MIL-A-23595/3B(AS)
AMENDMENT 3
31 May 2000
SUPERSEDING
AMENDMENT 2
23 May 1990

DETAIL SPECIFICATION

AMPLIFIER AUDIO FREQUENCY AM-7067A/A

FIGURE 3. Gasket PIN M23595/3-4

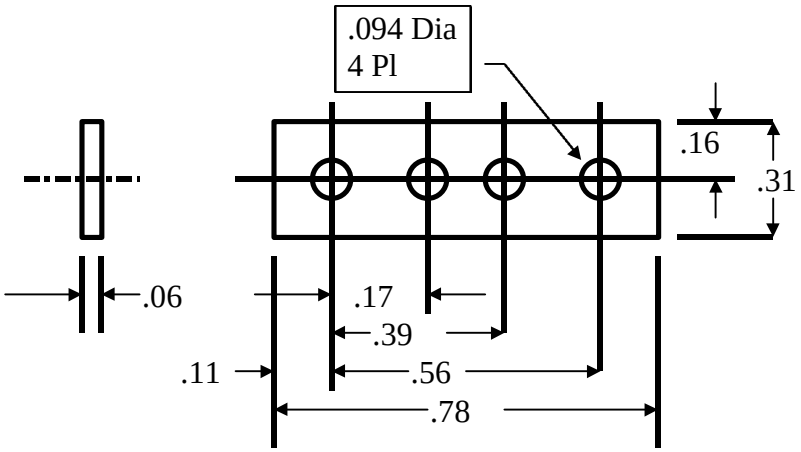
*Add Figure 3:
